Bridge-Unspecified
BRF-003-4(45)--38-99

PLANS OF PROPOSED IMPROVEMENT ON THE
PRIMARY ROAD SYSTEM
WRIGHT COUNTY
Bridge-Unspecified
Eagle Creek 5.3 mi E of Jct IA 17

PRELIMINARY PLANS

D2/D3 PLAN - Date: 7/14/2023

FILE NO.	ENGLISH	DESIGN TEAM TA/TAP	WRIGHT COUNTY	PROJECT NUMBER BRF-003-4(45)--38-99	SHEET NUMBER D2
----------	---------	--------------------	---------------	-------------------------------------	-----------------

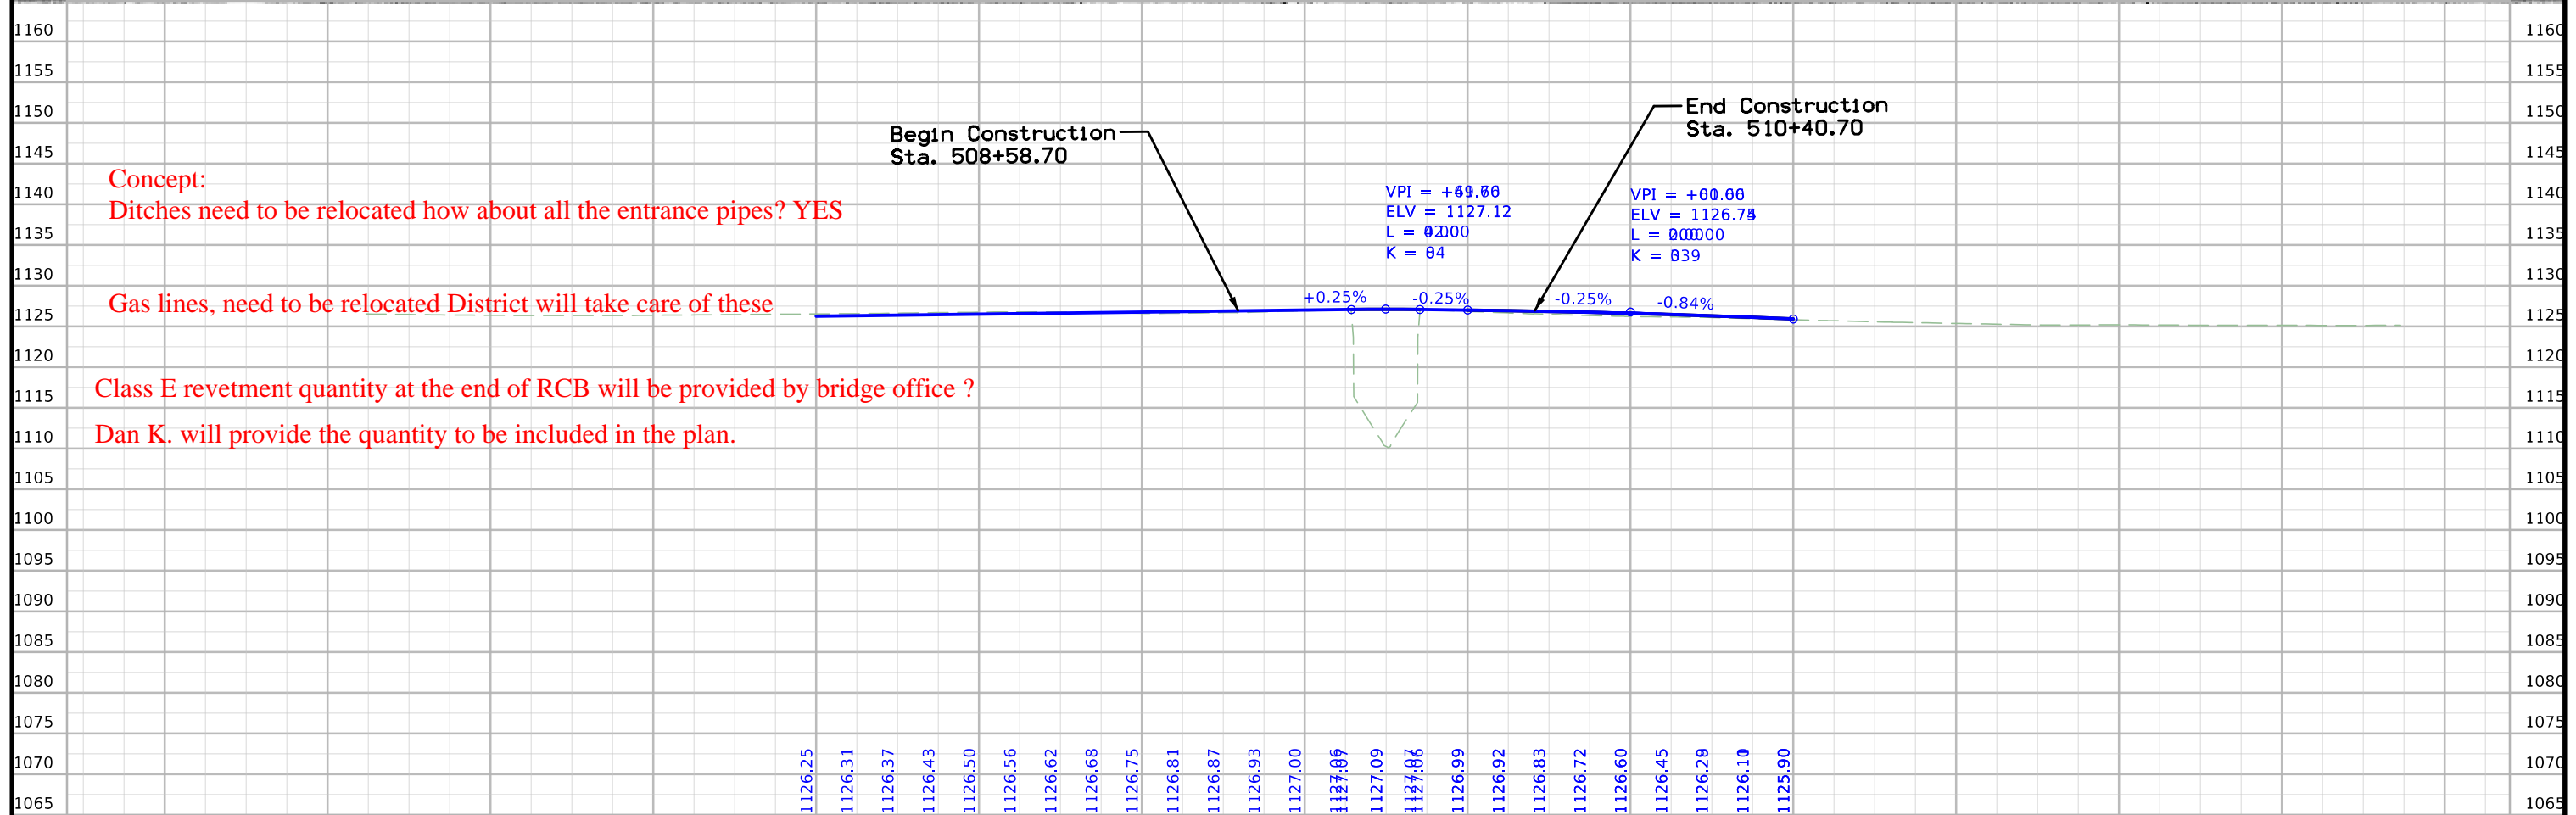
need to combine the construction line with the RCB

Concept:
Ditches need to be relocated how about all the entrance pipes? YES

Gas lines, need to be relocated District will take care of these

Class E revetment quantity at the end of RCB will be provided by bridge office ?

Dan K. will provide the quantity to be included in the plan.

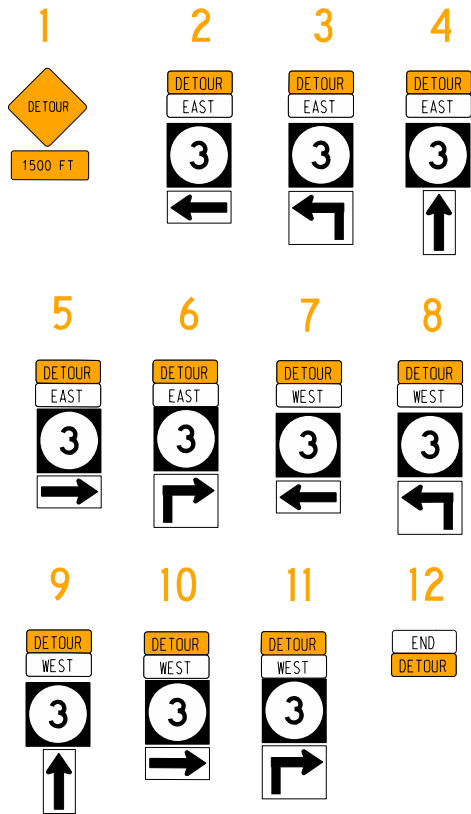
District will provide detour route sheet to be included in the plans
